Service Bulletin No: 32-031

**LANDING GEAR - WHEELS AND BRAKES  
MODIFICATION TO REPLACE THE LH AND RH BRAKE PIPES****1. Planning Information****A. Effectivity**

PC-12/47G series aircraft MSN 3001 thru MSN 3058, MSN 3060 and MSN 3062.

Brake Pipes - Pre Service Bulletin  
Figure 1 (Sheet 1 of 2)

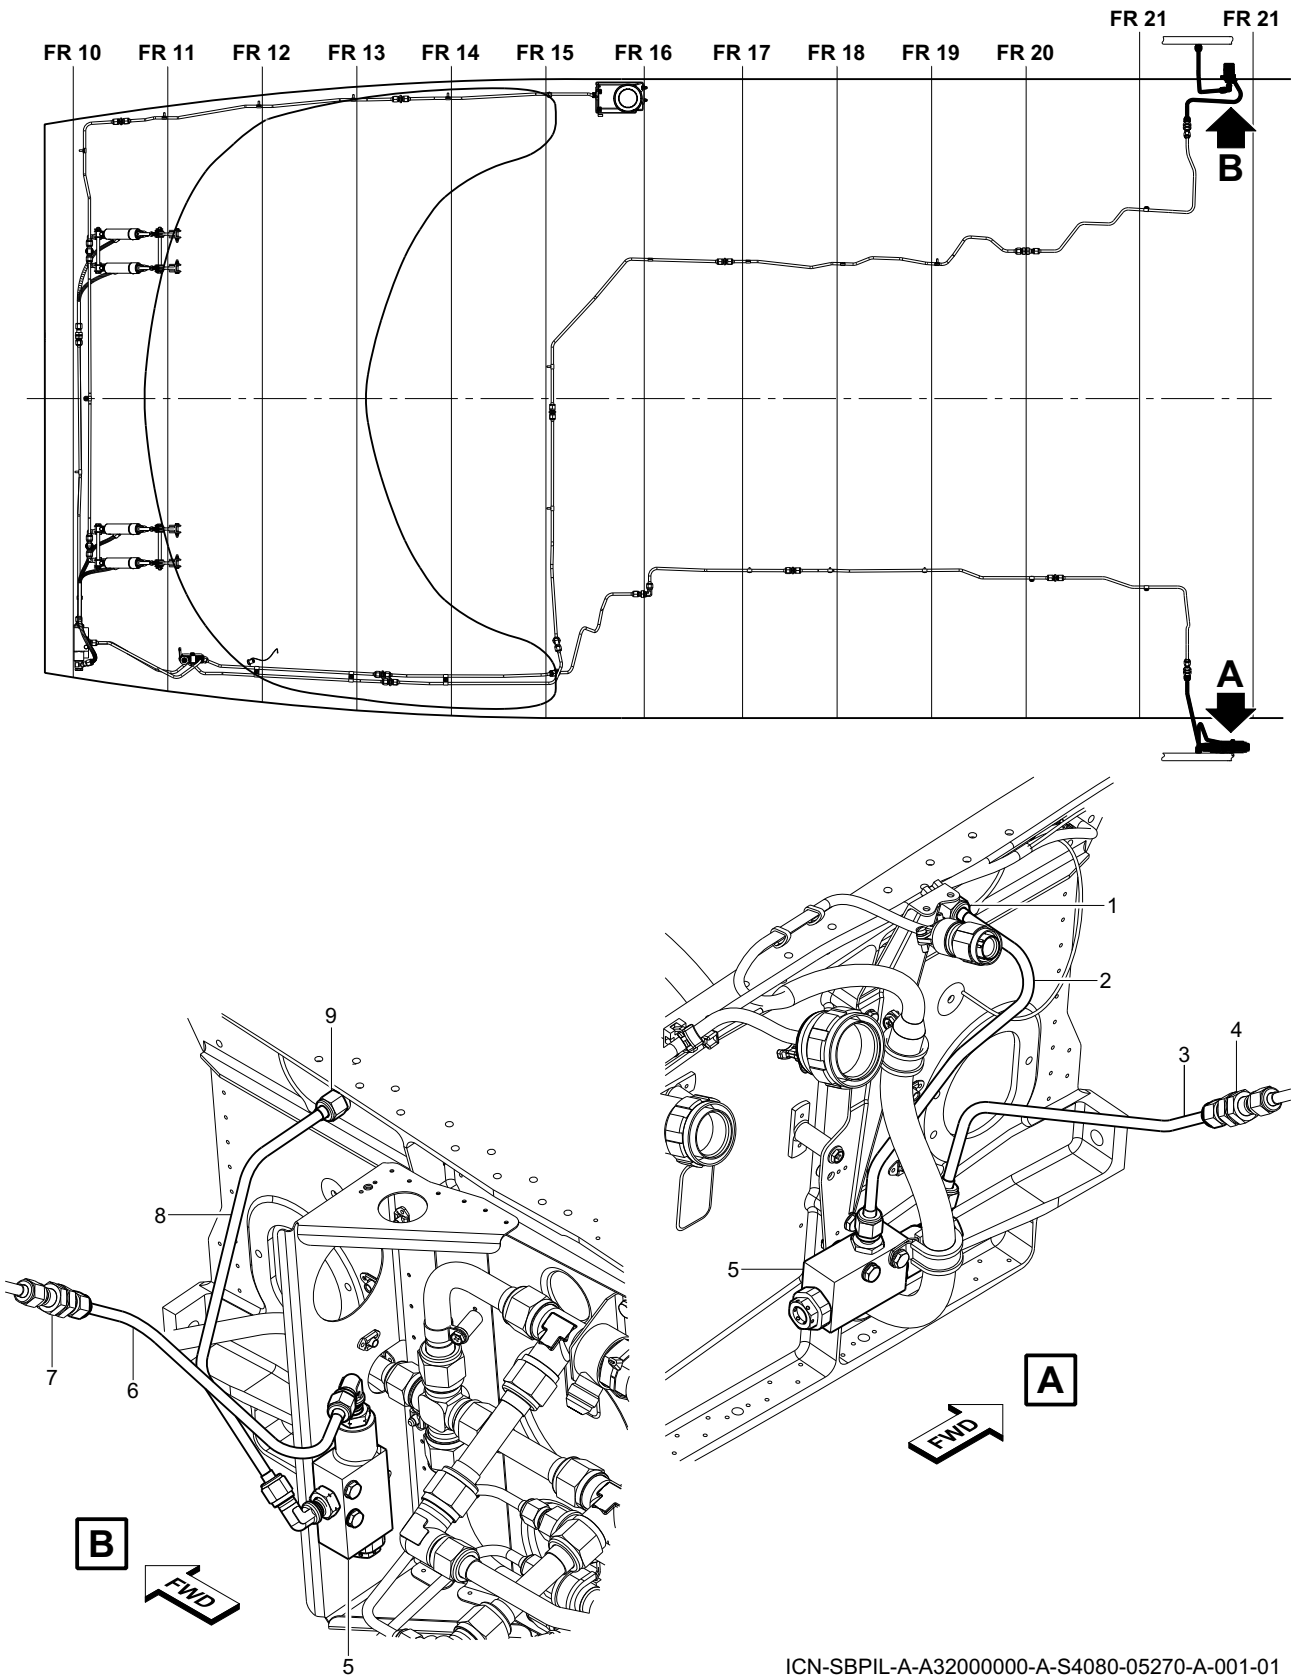
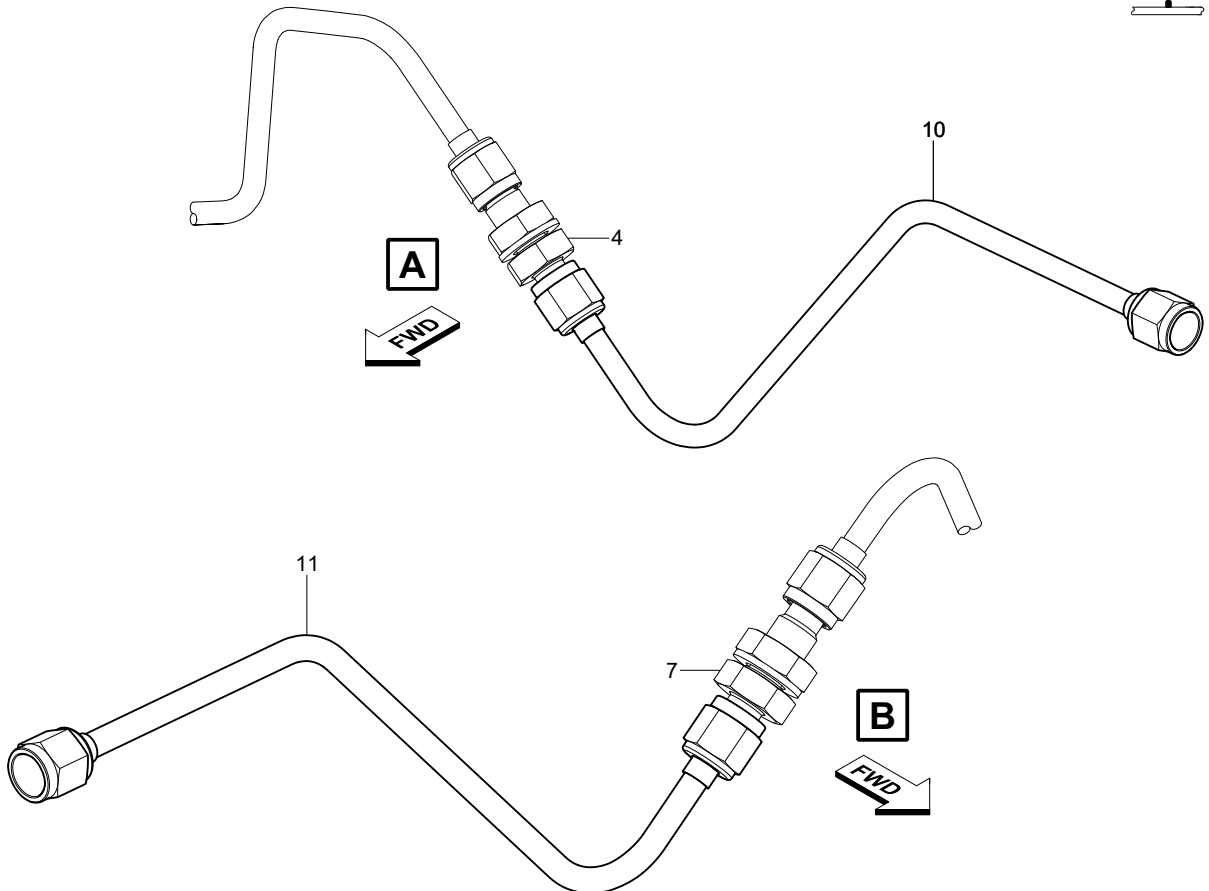
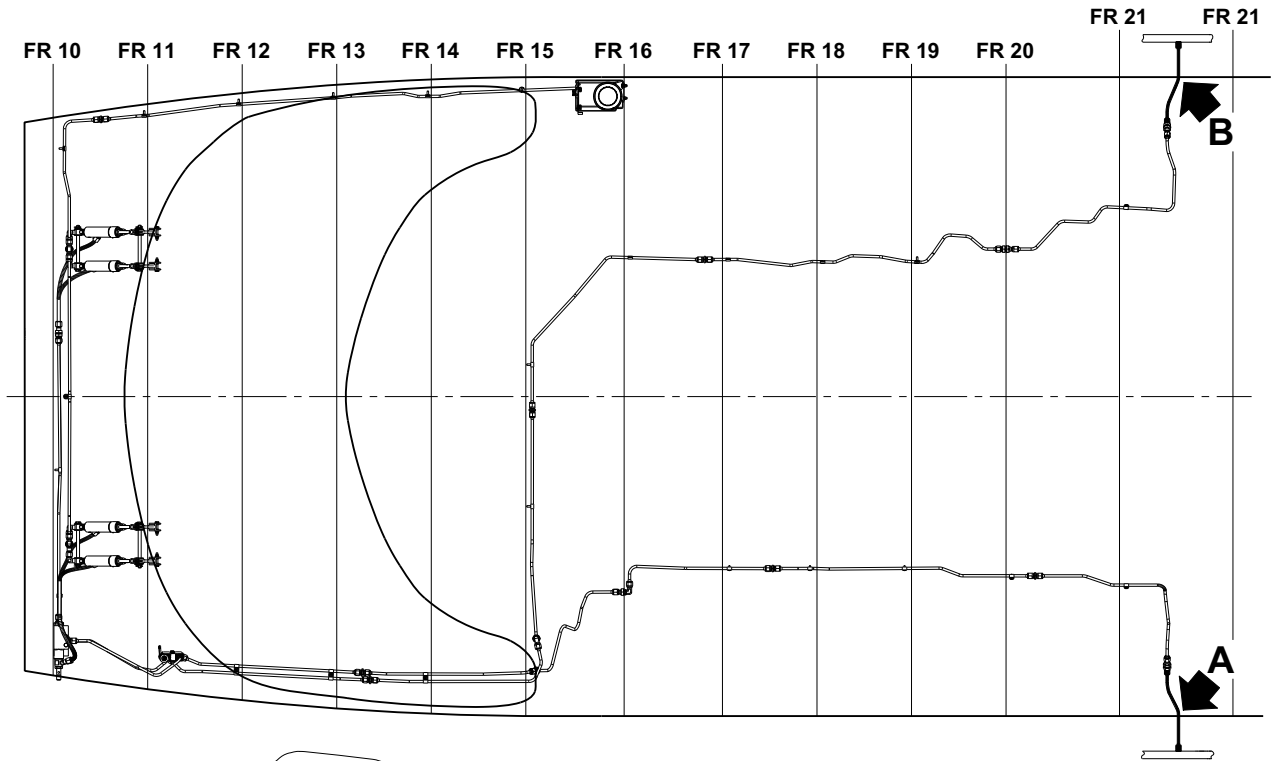
Due to an issue seen during production, the provisions for the Emergency Autoland (EAL) braking system (brake pipe going to the EAL Brake Shuttle Valve (BSV) and the brake pipe going from the BSV to the landing gear) need to be replaced with previously certified brake pipes.

On both LH and RH side the brake pipes, provisioned for EAL, are modified as follows:

- The pipe going into the EAL BSV, and the pipe going from the BSV to the landing gear are to be removed and replaced by the previously certified pipes
- The shuttle valves (LH and RH) remain installed and the ports are to be capped
- Provision fittings for EAL remain installed on the shuttle valves.

- (1) Left EAL BSV modification:
  - (a) Put absorbent paper (Material No. P02-031) below the brake shuttle valve (5) at wing rib 1.
  - (b) Disconnect and remove the hydraulic pipe assembly (2) (P/N 532.42.12.174) from between the fitting on wing rib 1 (1) and the brake shuttle valve (5).

- (c) Disconnect and remove the hydraulic pipe assembly (3) (P/N 532.42.12.173) from between the brake shuttle valve (5) and the fitting on the fuselage (4).

- (d) Install a new cap assembly (P/N 946.29.15.835) on the two empty brake shuttle valve (5) ports.
  - (e) Connect the new hydraulic pipe assembly (10) (P/N 532.42.12.137) between the fitting on wing rib 1 (1) and the fitting on the fuselage (4).

- (b) Disconnect and remove the hydraulic pipe assembly (8) (P/N 532.42.12.176) from between the fitting on wing rib 1 (9) and the brake shuttle valve (5).

- (c) Disconnect and remove the hydraulic pipe assembly (6) (P/N 532.42.12.175) from between the brake shuttle valve (5) and the fitting on the fuselage (7).
  - (d) Install a new cap assembly (P/N 946.29.15.835) on the two empty brake shuttle valve (5) ports.
  - (e) Connect the new hydraulic pipe assembly (11) (P/N 532.42.12.139) between the fitting on wing rib 1 (9) and the fitting on the fuselage (7).
  - (f) Use absorbent paper (Material No. P02-031) to clean any spilled hydraulic fluid.
- (3) Bleed the brake system. Refer to AMM 12-B-32-40-00-00A-902A-A.
